Beauly Blackhillock New Deer Peterhead
400 kV OHL
Report on Consultation – Corridor

March 2023

Title: **Figure 5.1: Beaully to Blackhillock Preferred and Proposed Corridors**

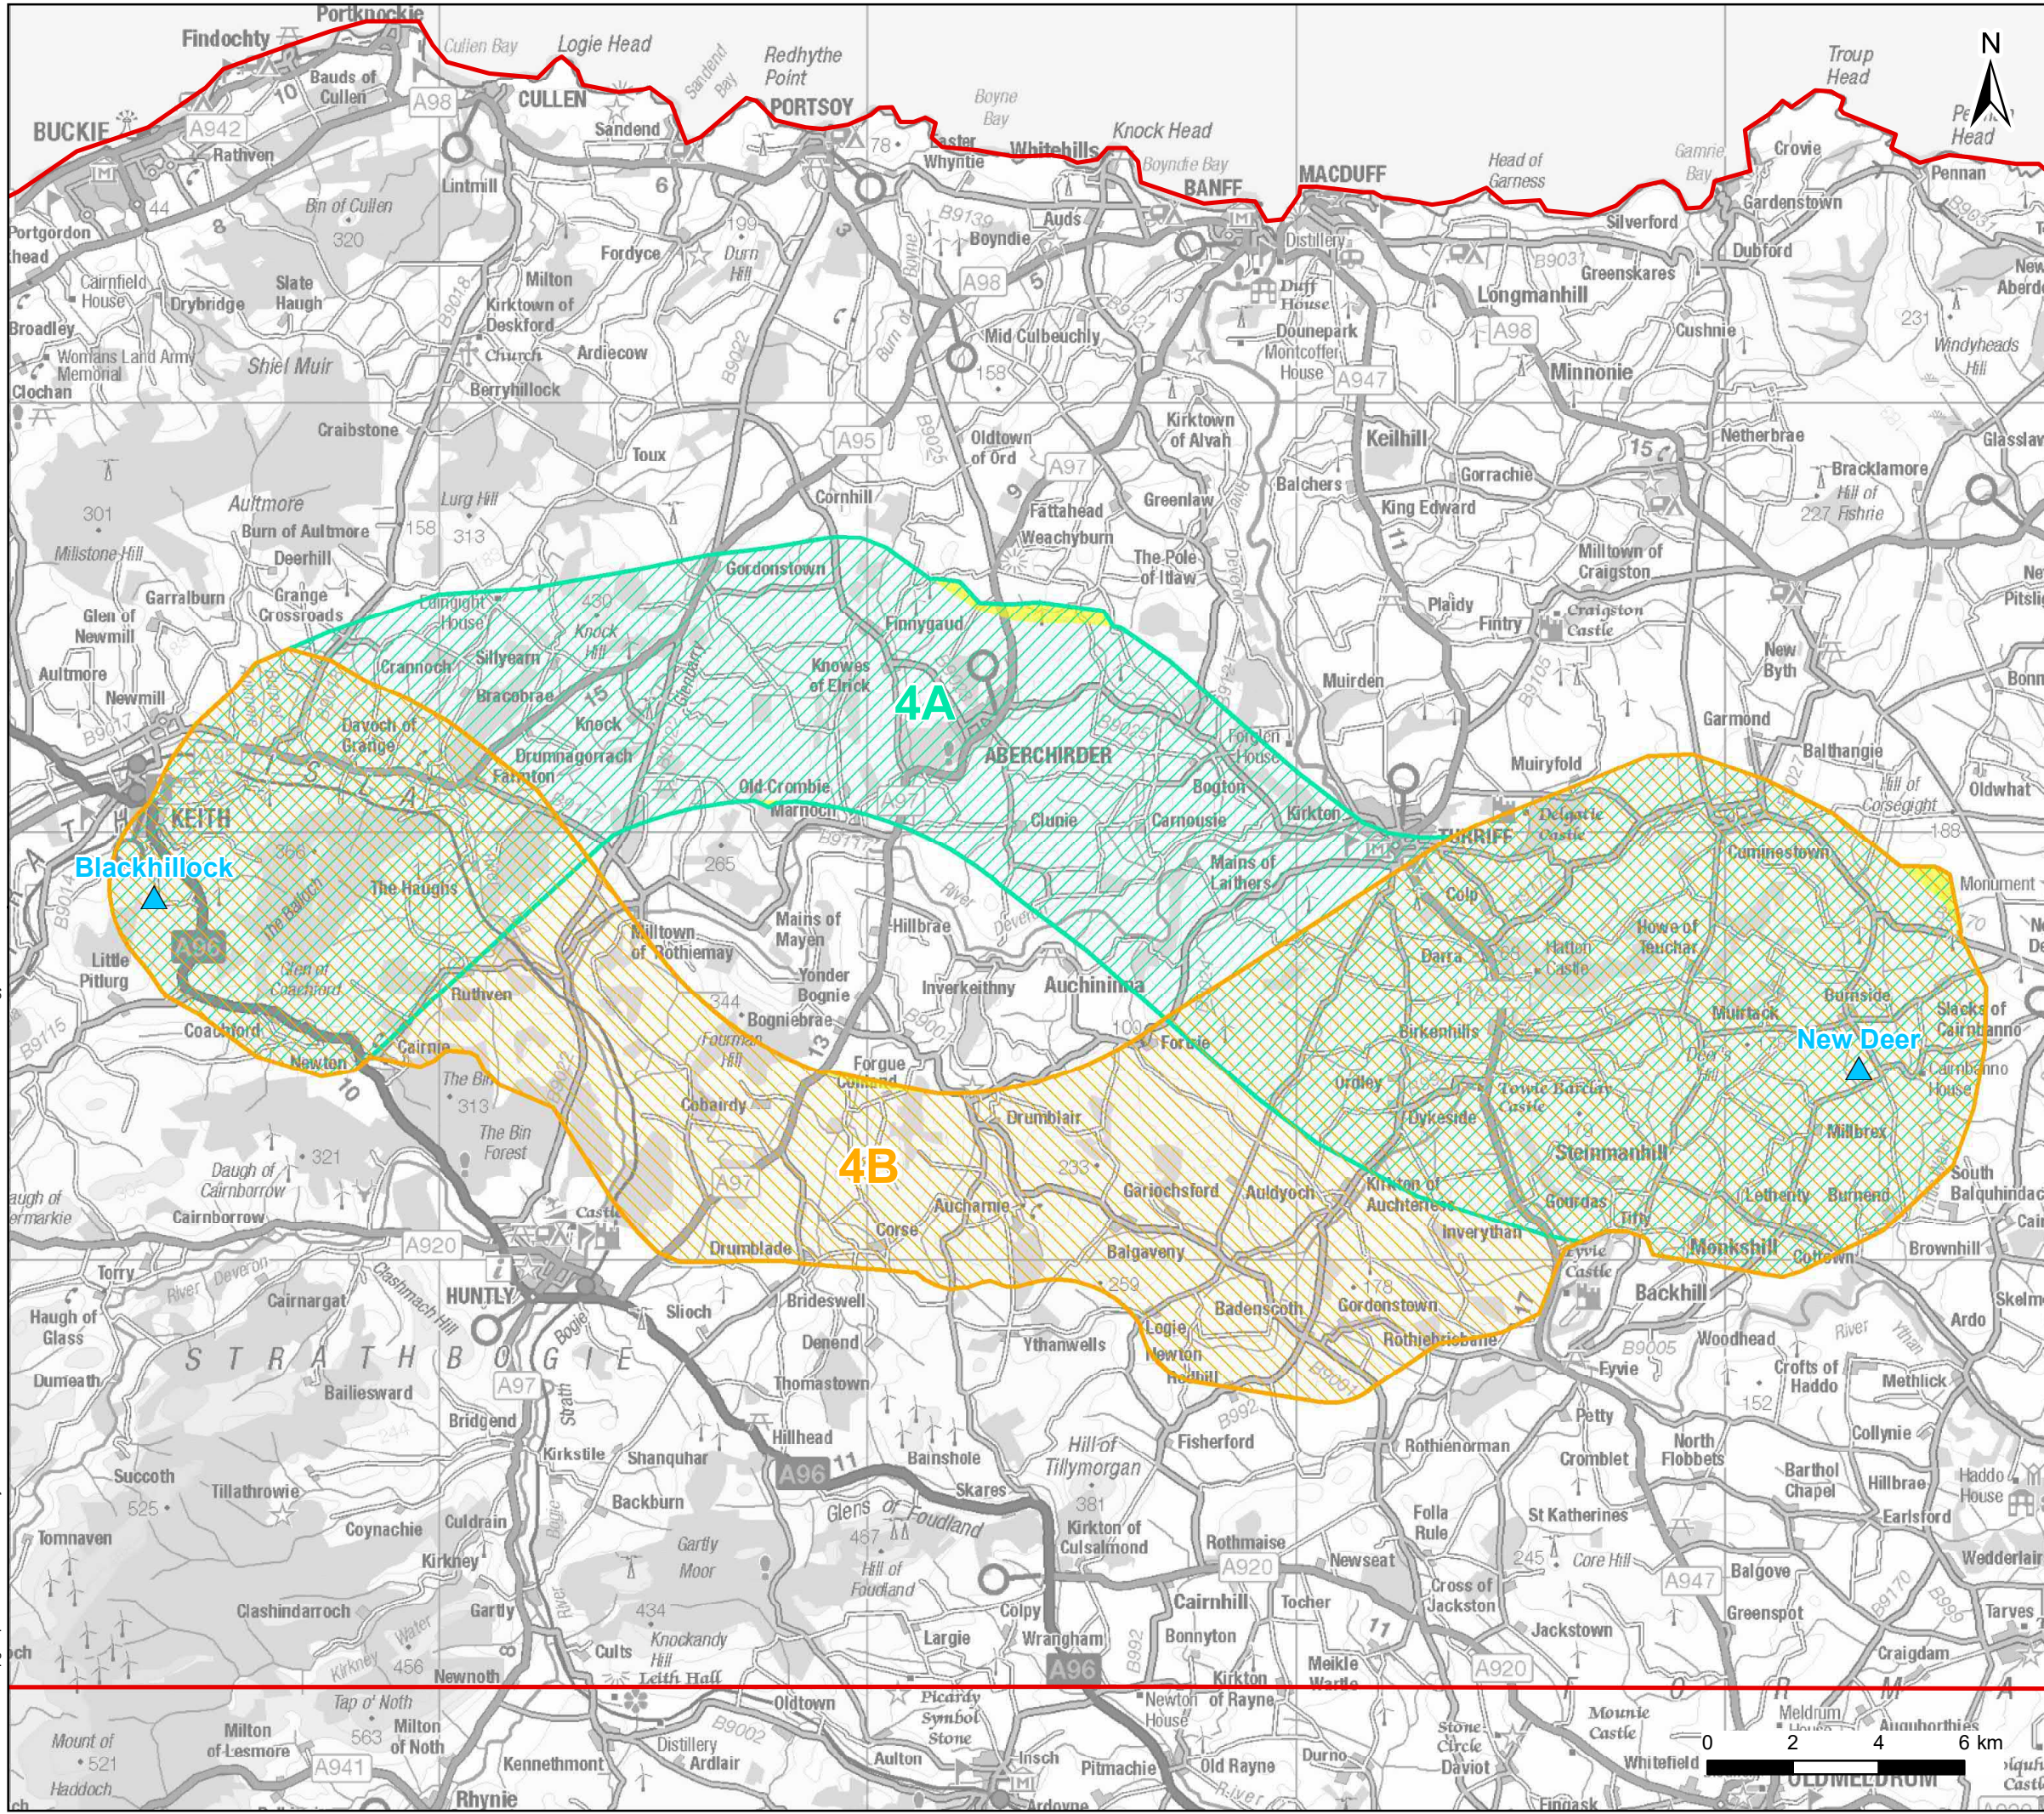
A number of deviations were made to the Preferred Corridor to arrive at the Proposed Corridor. These deviations are detailed below and can be viewed on **Figures 5.1, 5.2 and 5.3**.

Corridor 1A has been extended slightly at the most western extent. This is to allow additional space to develop route options to the preferred site for the proposed new Beaully Substation, which is being developed in parallel with this project.

Corridor 2B has been extended slightly to the north of Romach Hill to ensure there is suitable space to develop viable route options around the northern side of the hill at the next stage.

The western part of Corridor 3A has been extended to the south, near Moss of Bednawinny, following feedback from the public and landowners in the area. This is to widen the corridor in an area that is constrained by residential dwellings, to ensure there is suitable space to develop viable route options at the next stage.

Title: Figure 5.2 - Blackhillock to New Deer Preferred and Proposed Corridor

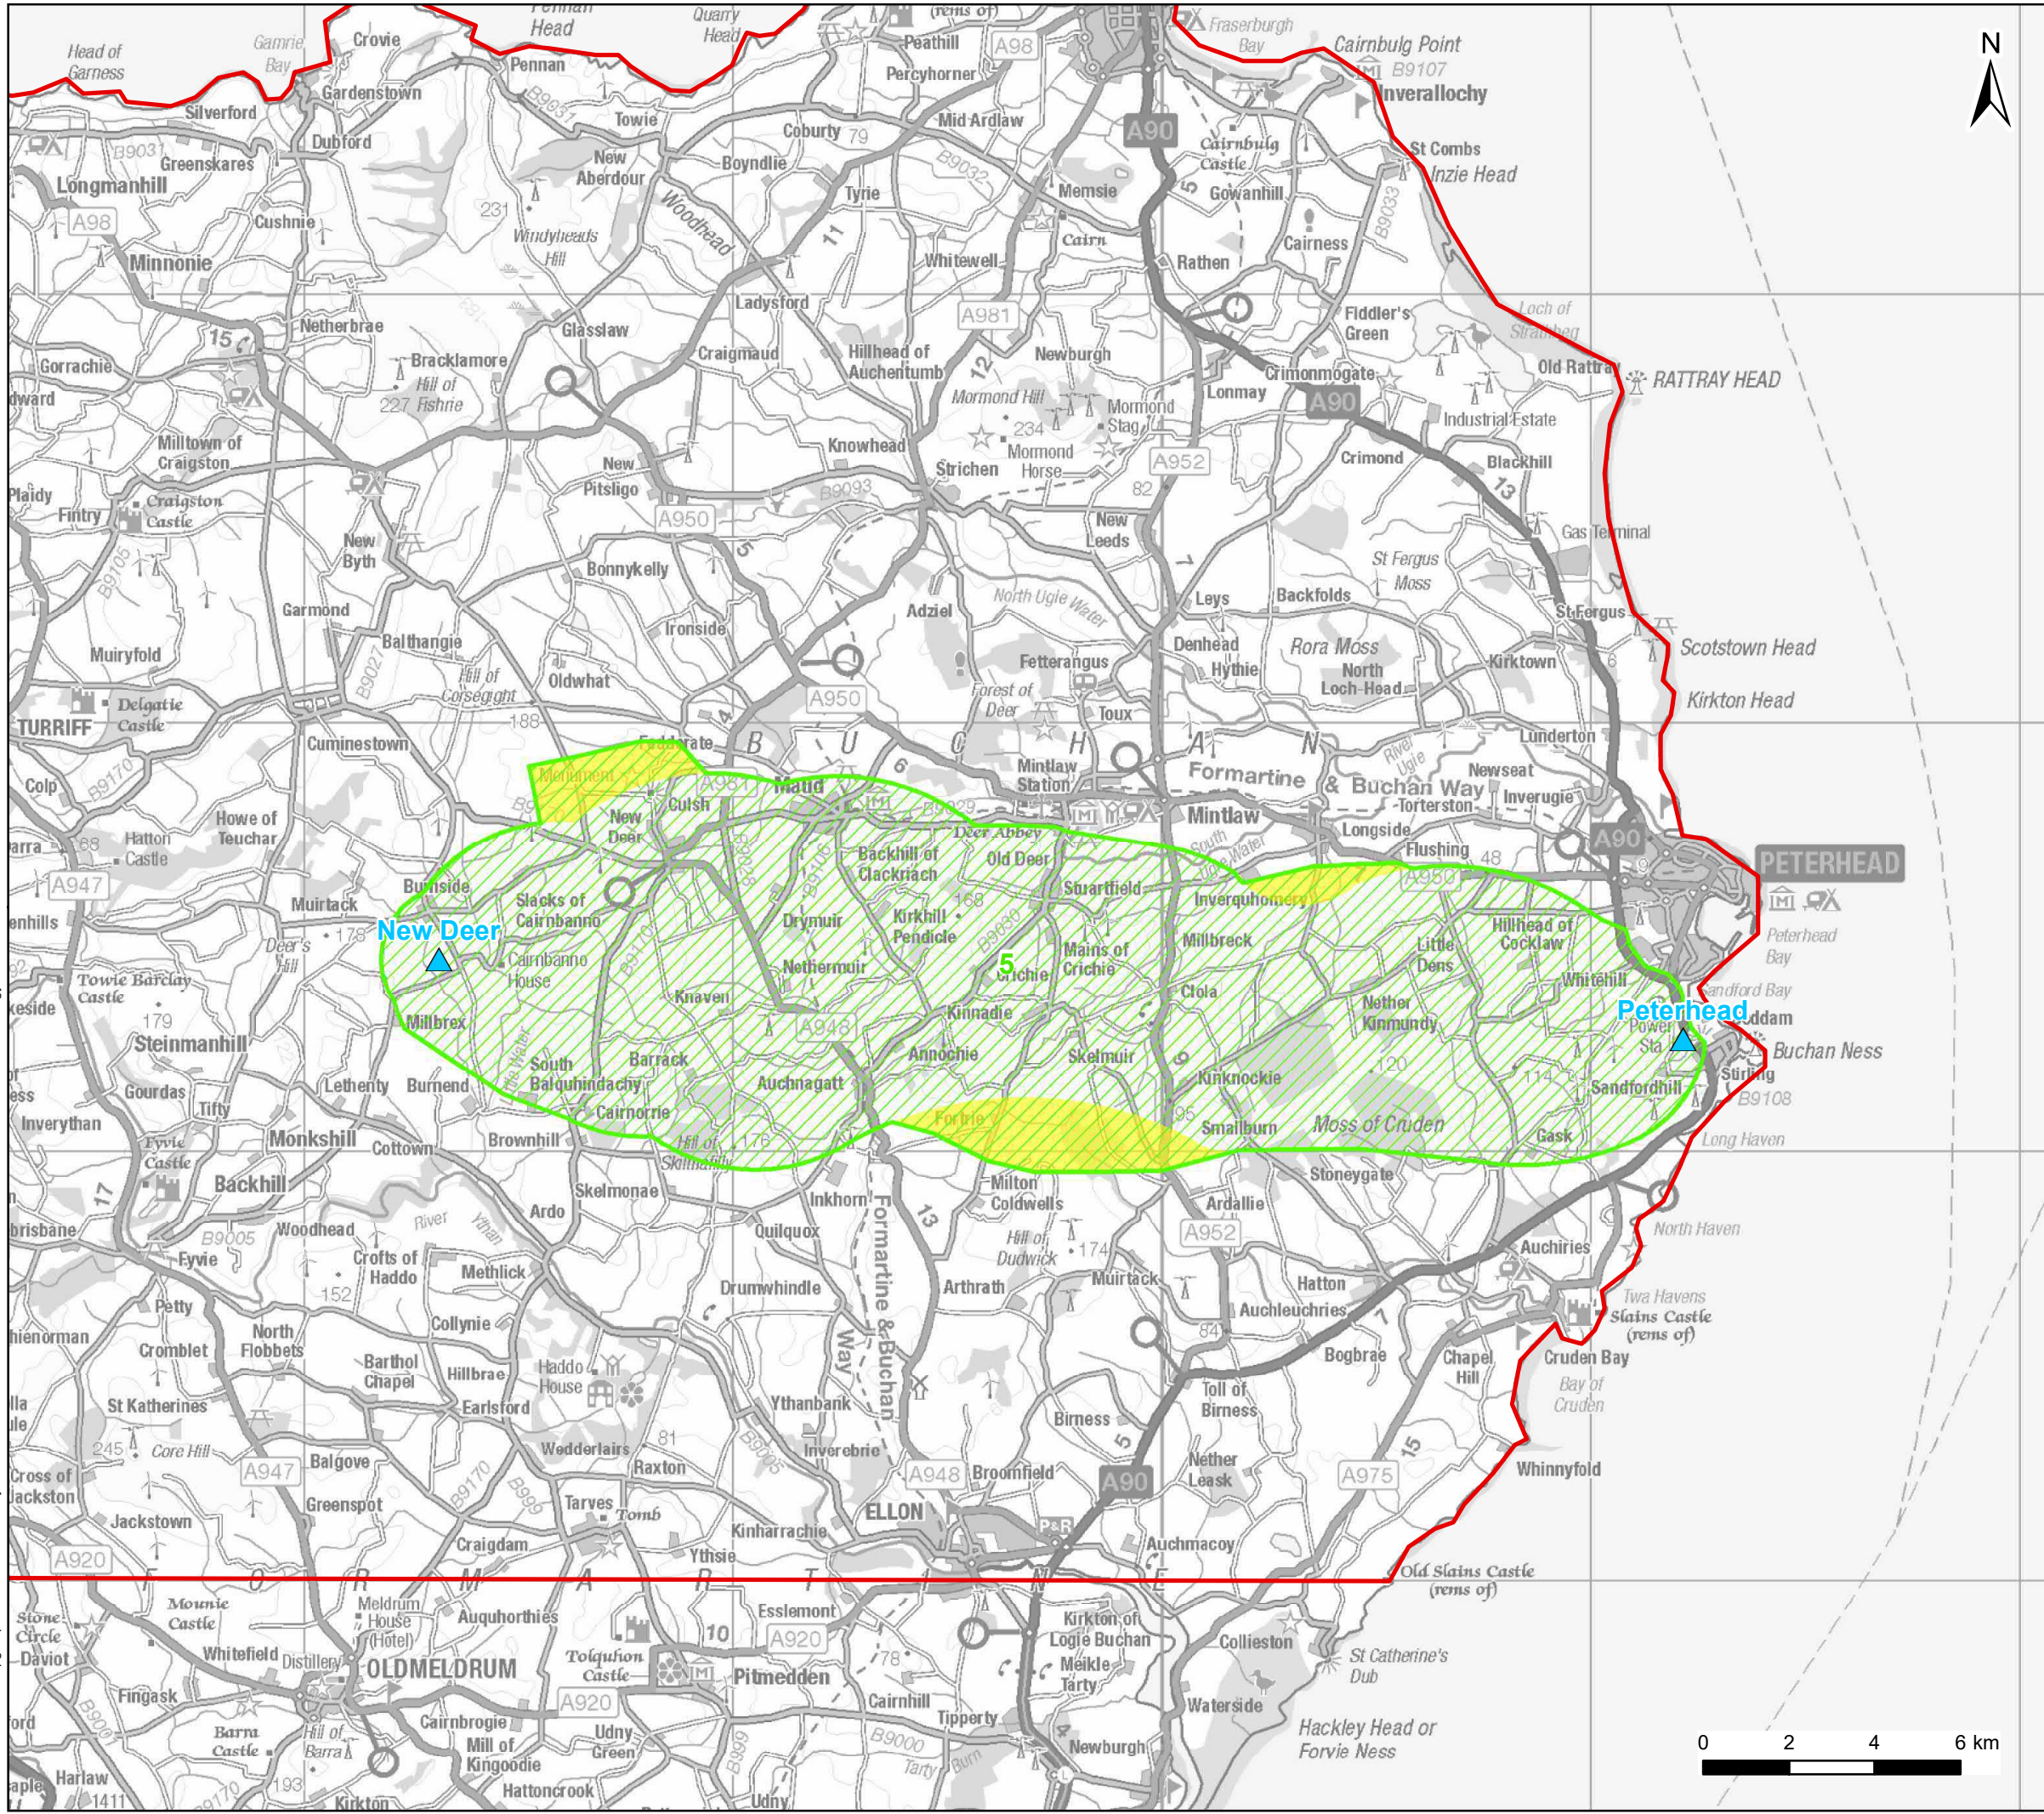
There is insufficient information to differentiate between corridor 4A (preferred corridor) and corridor 4B. Why is 4A the preferred?	<p>The environmental assessment of corridors 4A and 4B concluded that Corridor 4A was marginally preferred over Corridor 4B from a landscape and visual impacts perspective, as Corridor 4A has a slightly more low-lying, large scale open landscape with extensive energy infrastructure, which would help reduce setting and visual impacts. There is also more scope for avoidance of areas of forestry within Corridor 4A than 4B.</p> <p>From an engineering perspective, Corridor 4A was again marginally preferred over Corridor 4B, as there is a lower likelihood of requiring major crossings of existing overhead line infrastructure.</p> <p>Following feedback received at the consultation events regarding the sensitivity of the Deveron Valley landscape within Corridor 4A, and due to the marginal differences in our assessments of the corridor options, we have reviewed our Preferred Corridor within this section and taken the decision to include both Corridors 4A and 4B in the next stage of</p>

Corridor 4A has been extended slightly further north, to the north of Aberchirder, following feedback from the public and landowners in the area. This is to widen the corridor in an area that is

constrained by landscape and potential visual impacts, and ensure there is suitable space to develop viable route options at the next stage.

The eastern extent of Corridor 4A has been extended north, to the north of New Deer. This is to allow additional space to develop route options to potential sites for the proposed New Deer 2 substation, which is being developed in parallel with this project.

To ensure there is suitable space to develop viable route options at the next stage marginal deviations to the corridor boundary have been made to the southern boundary of Corridor 4A west of Marnoch, and within Corridor 4B to the north east of Cairnie and to the south of Forgue.

Following the feedback provided during the consultation period, the decision was made to include both corridor options (4A and 4B) within the Proposed Corridor to take forward to the Route Selection Stage. This was largely due to feedback highlighting the use of Crombie Moss by Common Crane, and proximity to settlements in Corridor 4A. By taking both corridor options forward to the route selection stage, potential route options can be explored within both corridor options to ensure the optimum Preferred Route can be established to take to the next round of consultation.
